Davis-Besse Nuclear Power Station
 Offsite/Onsite Organization
 Figure 6.2-1

8707090259 870630
 PDR ADOCK 05000346
 P

ADMINISTRATIVE CONTROLS

DAVIS-BESSE NUCLEAR POWER STATION
OFFSITE/ONSITE ORGANIZATION
FIGURE 6.2-1

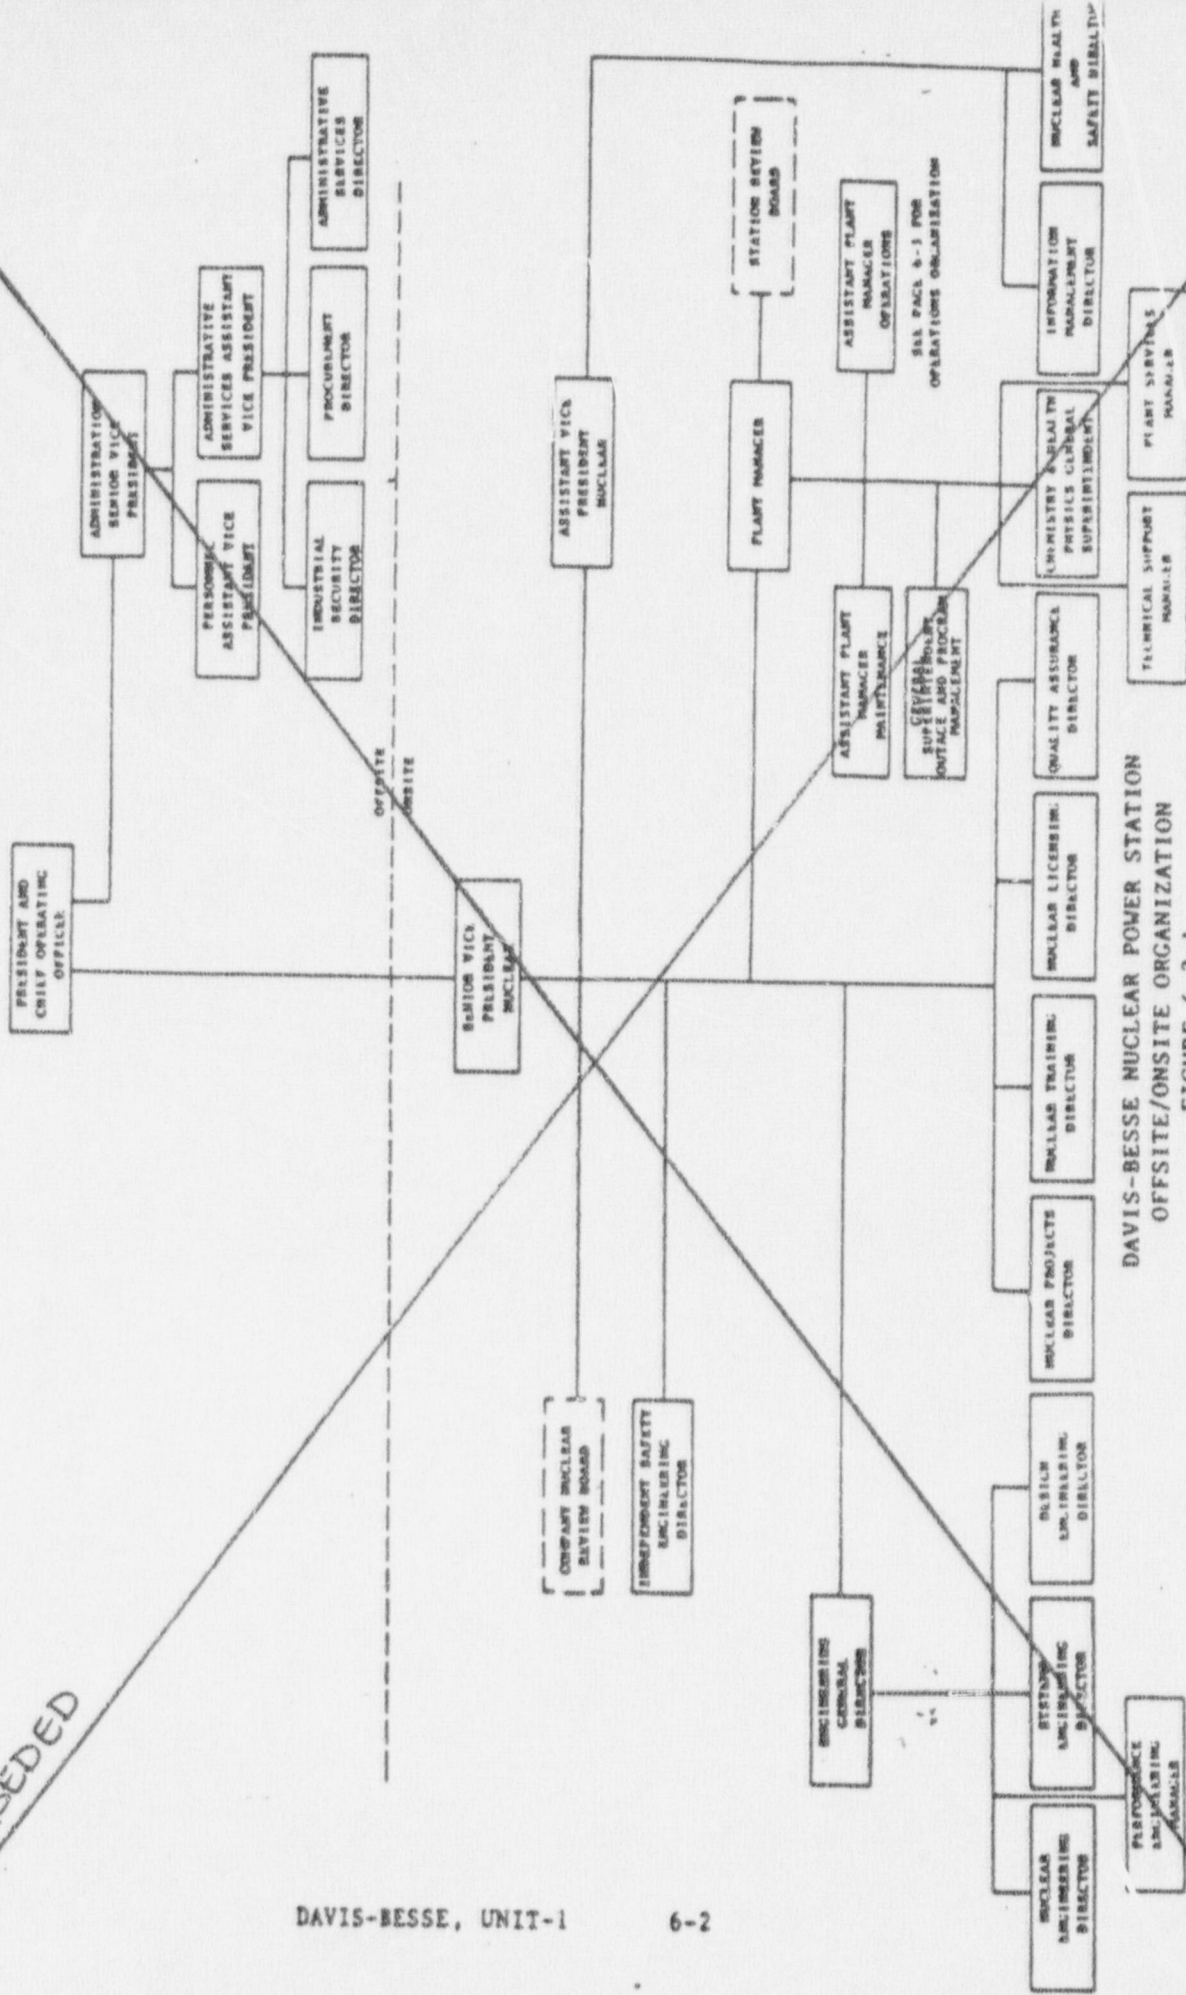
SUPERSEDED
